**Kawa Stream
Flood Control**

REVISED
ENVIRONMENTAL IMPACT STATEMENT
FOR THE
KAWA STREAM
FLOOD CONTROL PROJECT

Kaneohe, Oahu, Hawaii
TMK: 4-5-34, 61, 62, 63, 66, 67, 70, 84 & 89

Date: August 17, 1977

LAND USE

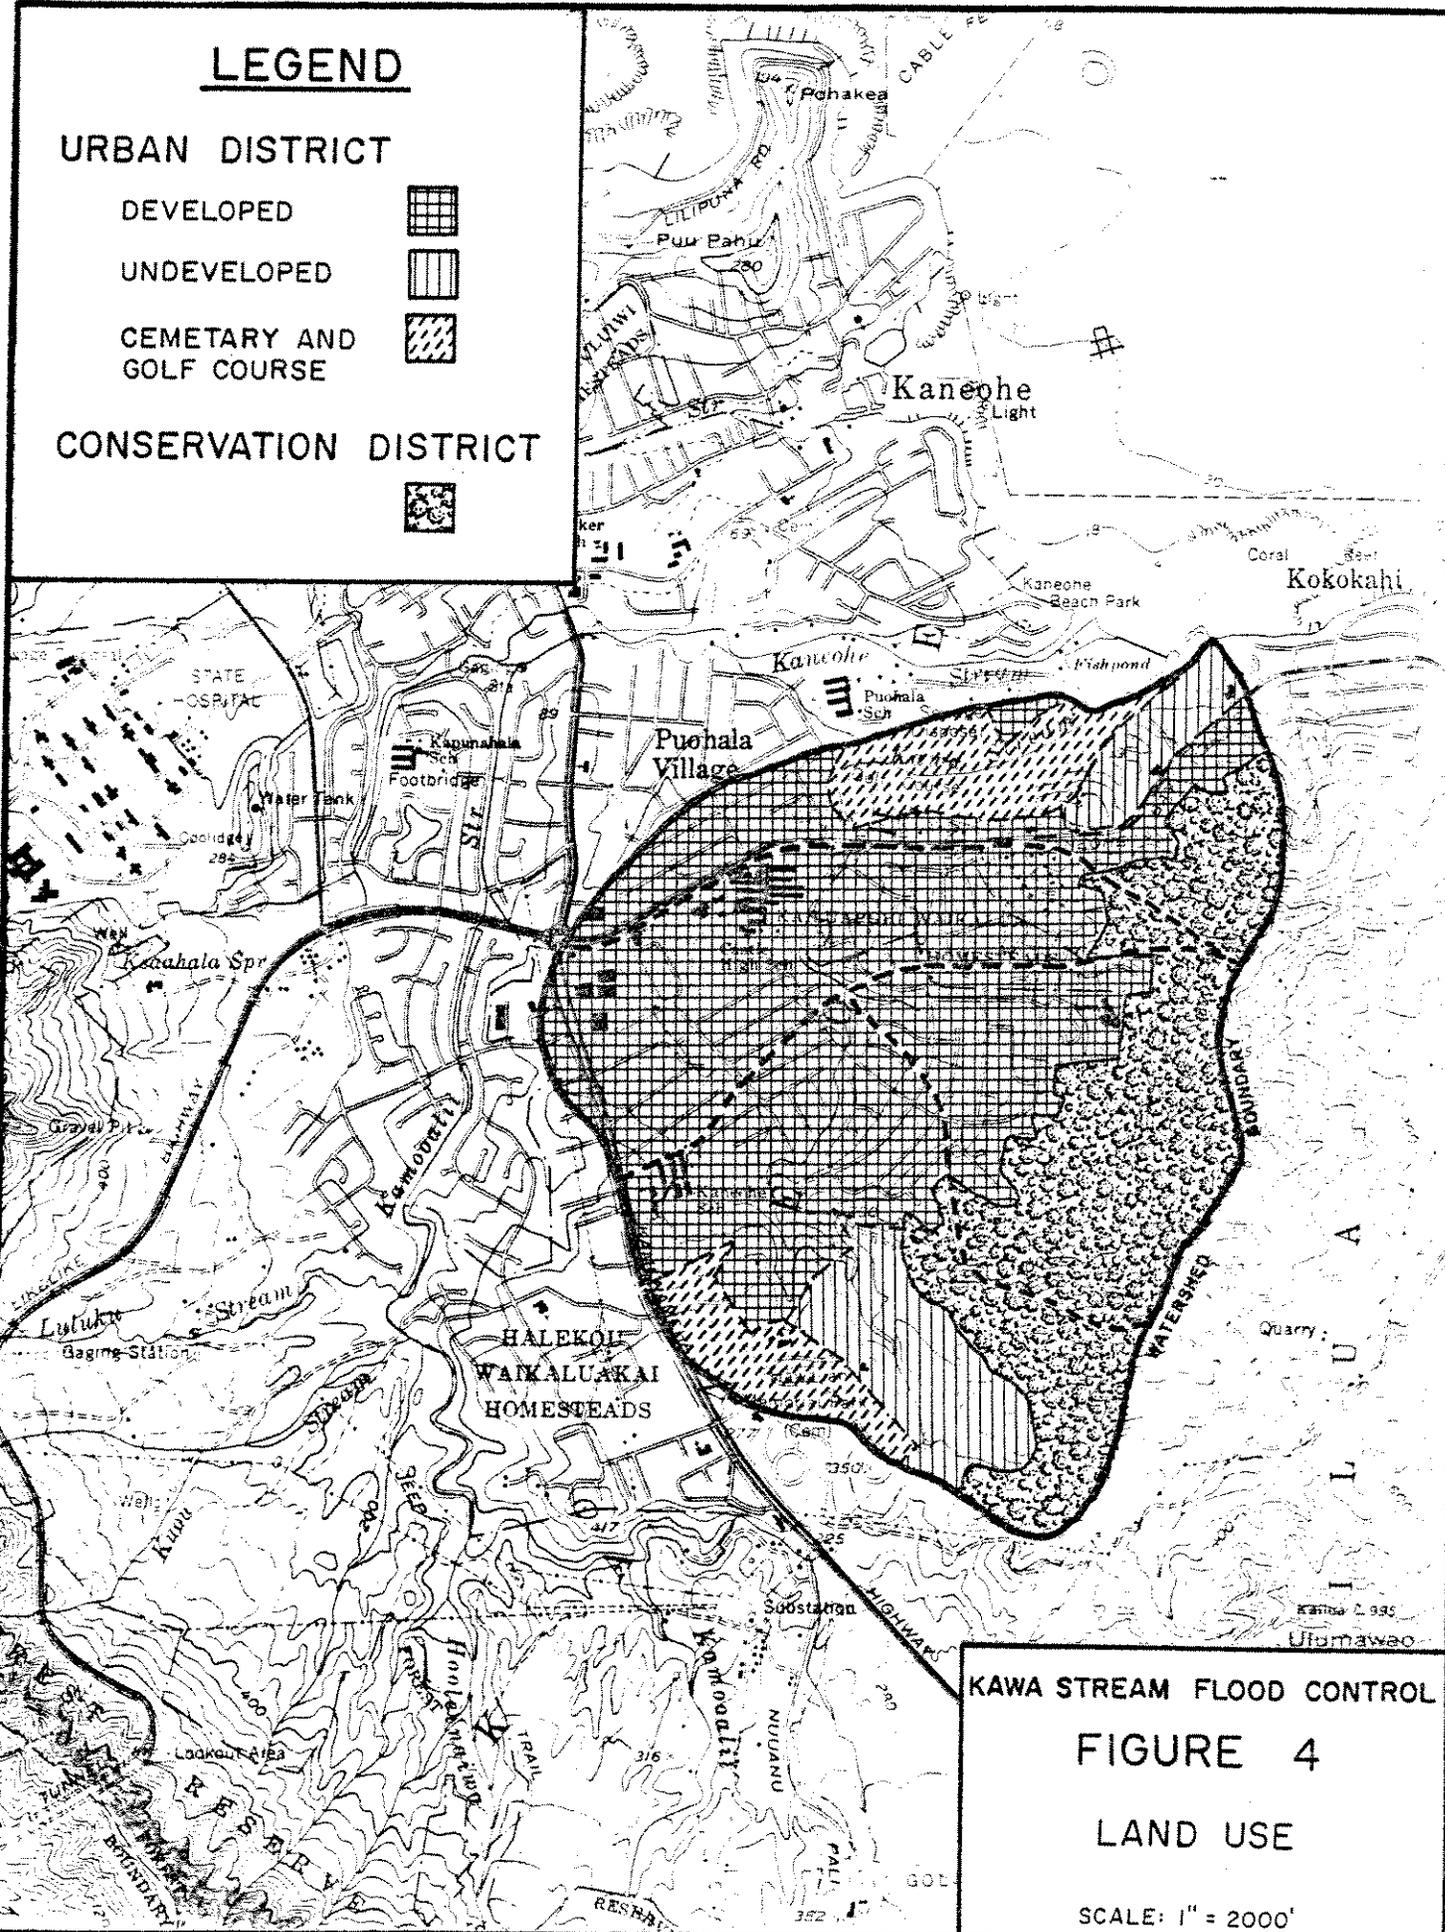
6. The preparation notice indicates that there are 120 acres of residentially zoned land and 250 acres of preservation, agriculture, park and cemetery land upstream of the project (p.5.) These should be shown on a generalized land use map. The EIS should also provide estimated stream flows and sedimentation loads from areas upstream of the project before and after projected development, particularly since it is indicated that "If the remaining residential acreage is developed, the flooding situation could worsen" (p.5, par.3.)

6. The existing land use in the watershed will be shown. However, the storm runoff and sediment load from potential land development projects in the upper watershed is independent of the proposed project; predicting the hydrologic impacts of such development is, therefore, beyond the scope of this EIS. The comment to which you refer, regarding the potential impact of upstream development, is qualitative, not quantitative.

Previous Stream Alterations

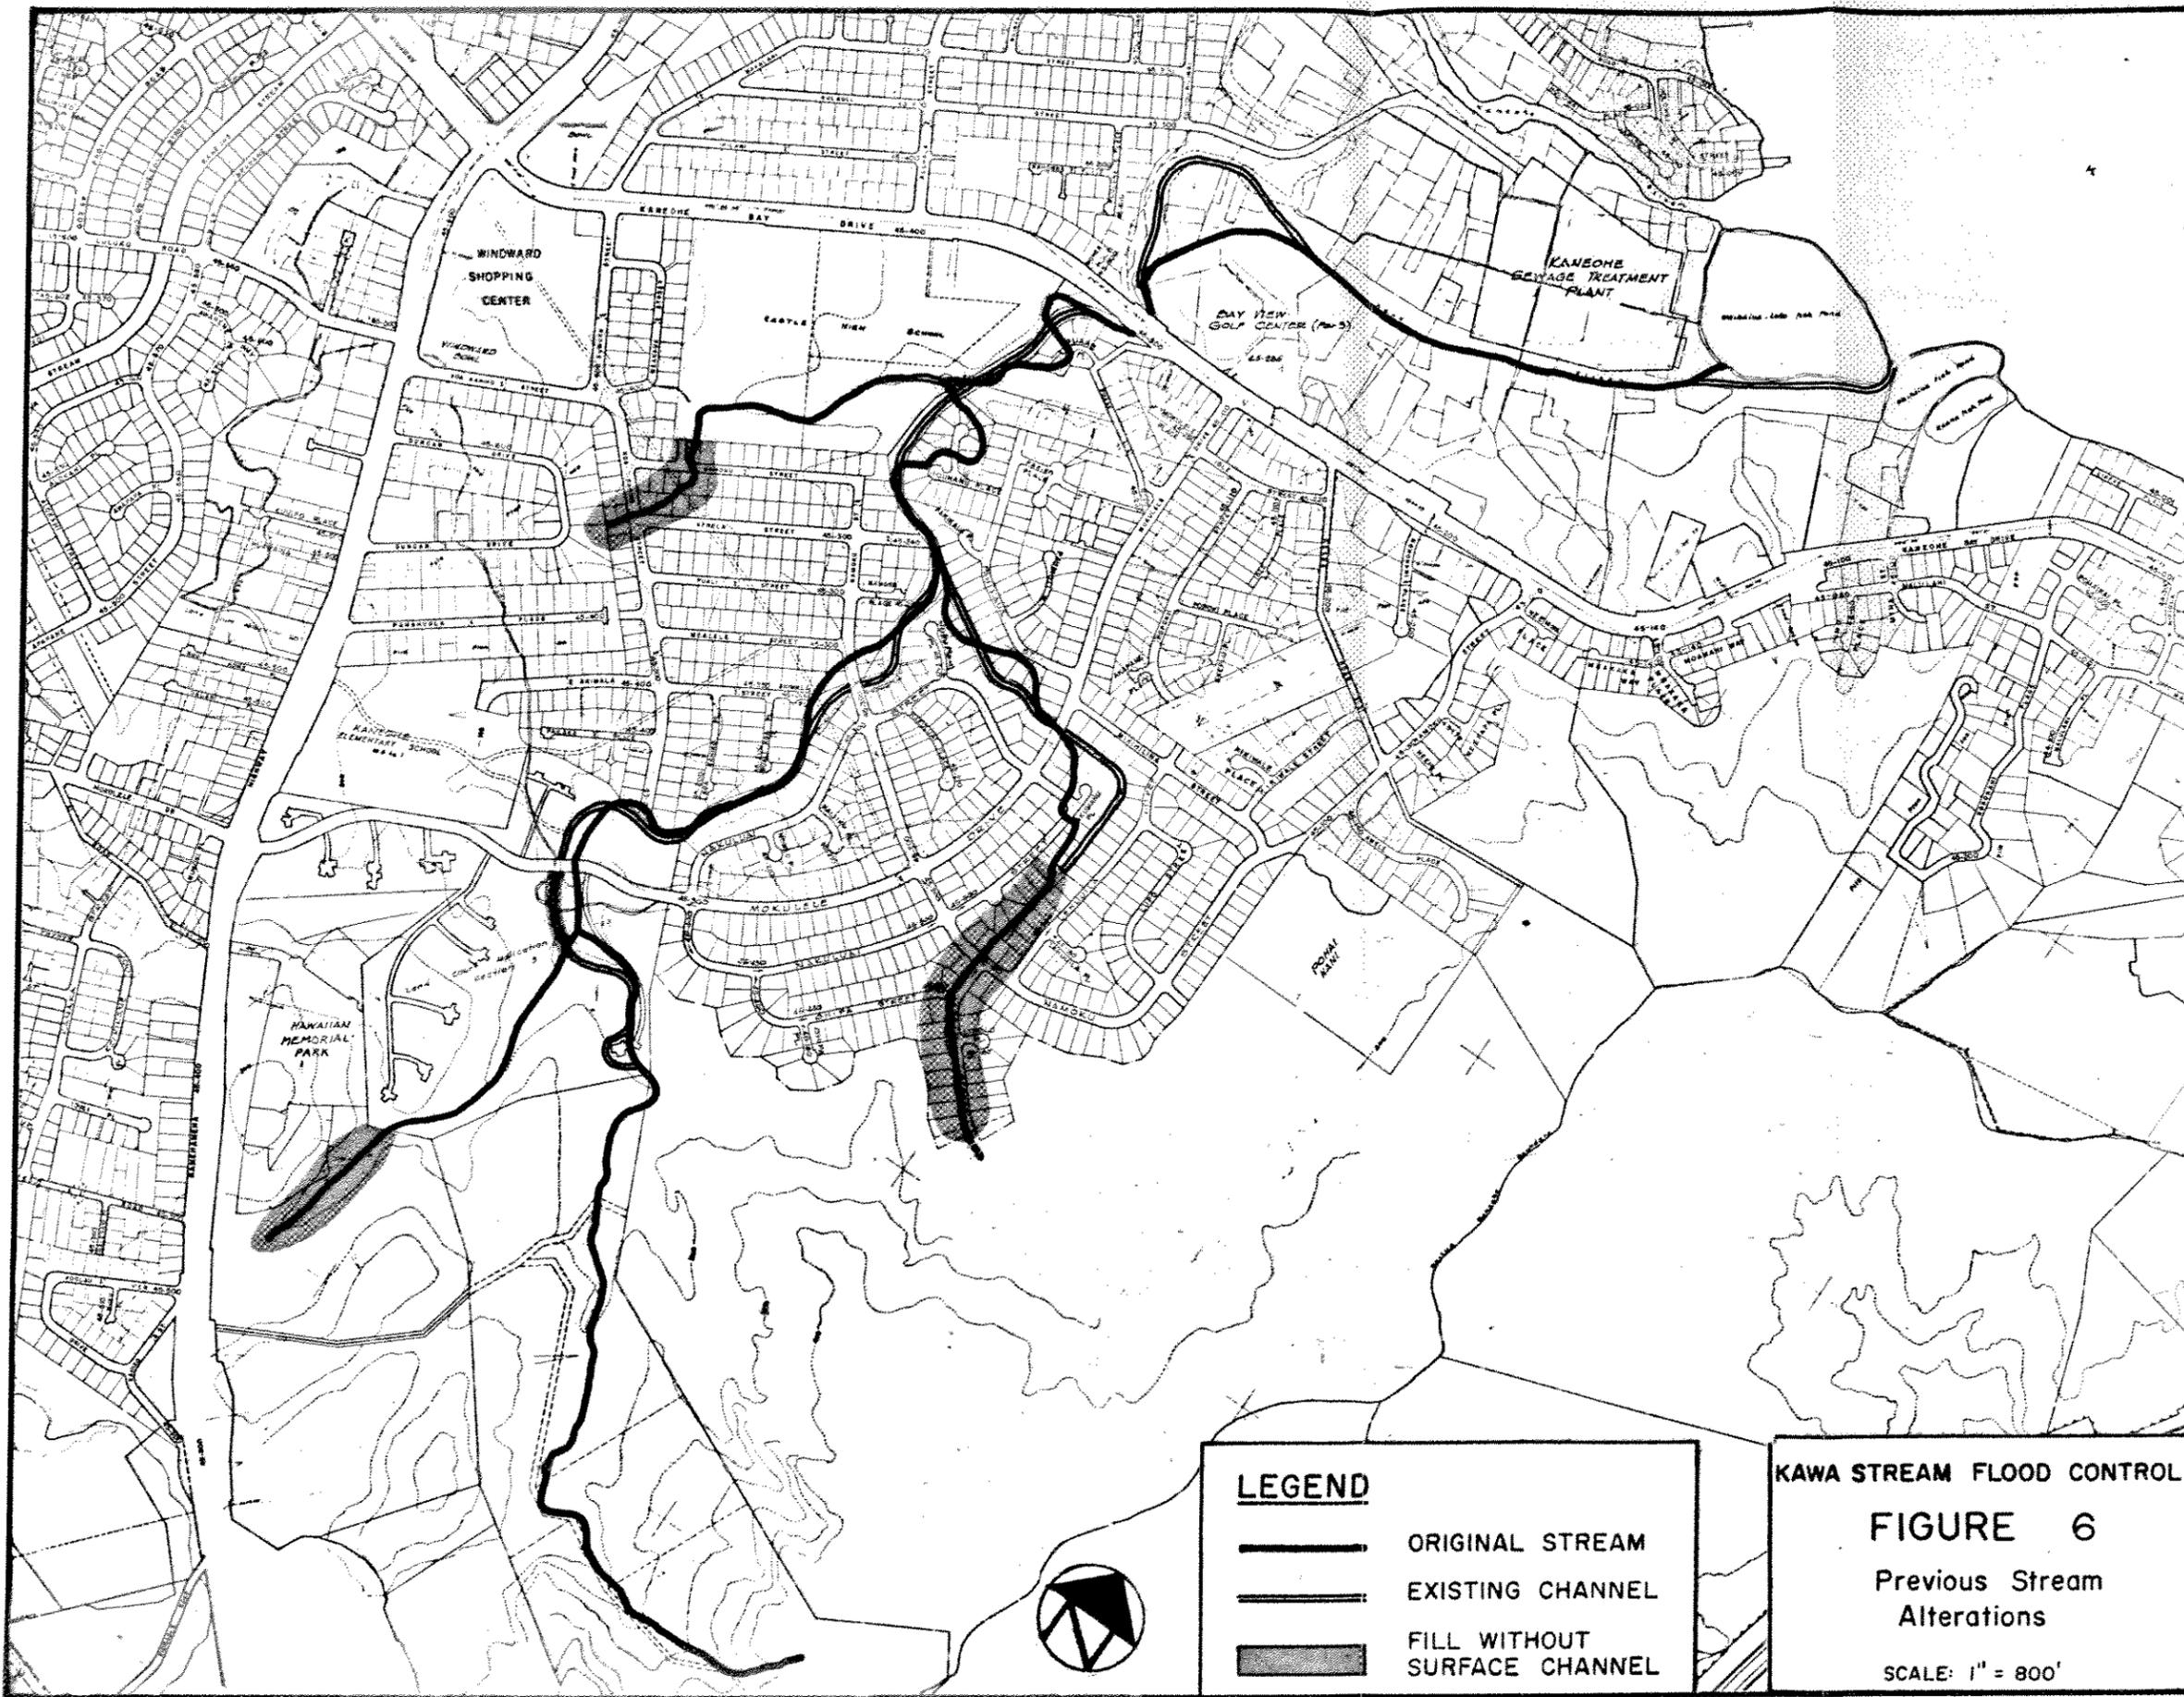
1. The EIS should provide estimates of expected State aid and/or an indication of State and County funding.
2. The description of existing stream conditions (p.4., par.2) should include a map showing what areas are lined, partially-lined, and natural; and what areas are fenced.
3. Previous floods are mentioned, with peak flow data for a February 1969 storm. Peak discharges for the three increments are given (p.2.) The design flood should be specified.
4. The sedimentation load from Kawa Stream into Kaneohe Bay is 320 tons per year out of an estimated 35,000 tons per year. This is less than 1 percent of the total. It is also indicated (p.5) that Kawa Stream contributes the least amount of the three stream discharging into the south bay. The EIS should include some discussion on the other streams and how this project relates in terms of priorities for improvements.

Alternative Invert
Modifications

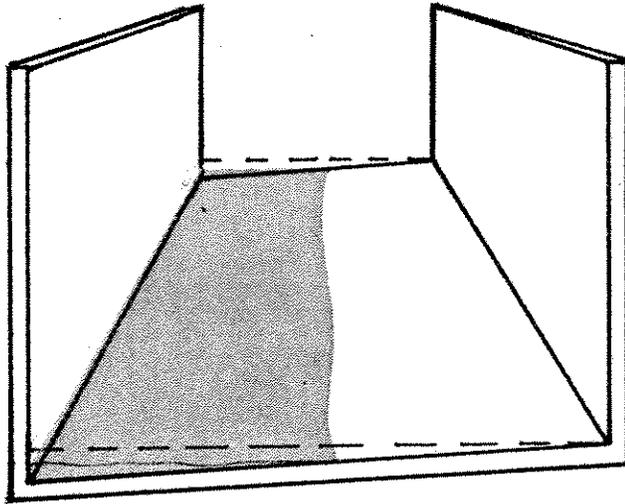
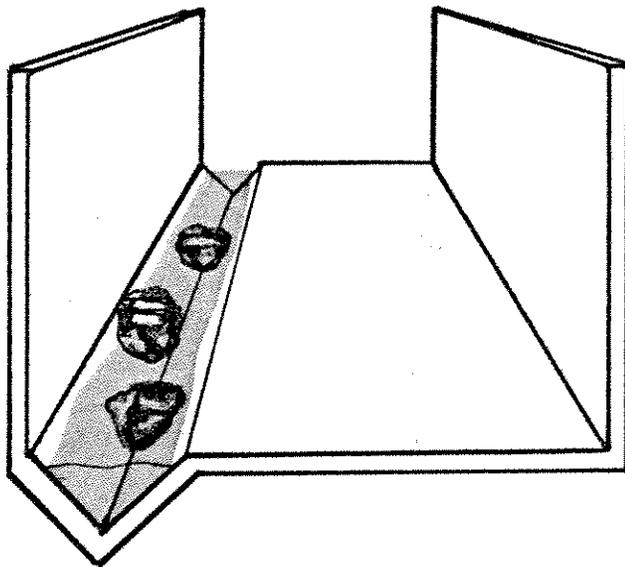
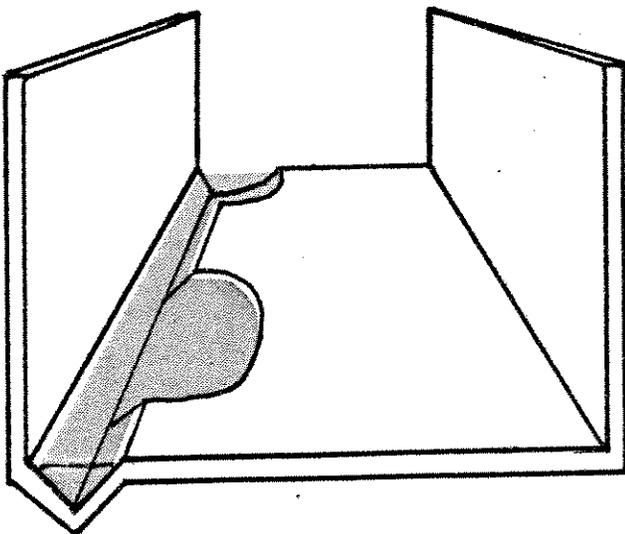
Page 9, Sec. VII. Alternatives, should consider other engineering designs, such as riprap or rock masonry banks, in those areas subject to erosion, which involve minimal stream modifications while reducing environmental impacts to Kawa Stream and Kaneohe Bay.

The most promising modification is the first one pictured on Figure 7. It consists of simply superelevating (tilting) the invert approximately 5% so that the base discharge flows along one side of the channel. This is normally done on curves to counteract the tendency of the water to rise up on the outside wall when it is flowing at a high velocity. Where it would not conflict with the superelevation at a curve, the water could be directed to the shadiest side of the channel; on Kawa Stream this would be the westerly bank (shaded from the afternoon sun). Concentrating the water and keeping it in the shade should prevent it from getting too hot. The water would also vary in depth and velocity, so that fish could find the current most to their liking.

The other concepts considered consisted of more well-defined low-flow channels to provide a greater degree of concentration of the water. However, these channels would also produce a greater flow velocity than if the water were more spread out; therefore, some type of obstruction (such as rocks) or slow-water area (such as pools) or combination of the two, would be required so that the fish could maintain their position in the channel. The major problem with these concepts, aside from their greater construction cost, is that they would introduce an "irregularity" in the channel.

At high volumes, this would cause an unstable flow and could necessitate a larger channel. Also, any depression would have a tendency to fill with silt, thus defeating its intended purposes. Superelevating the invert slightly would not cause these problems and would not greatly add to the construction costs.
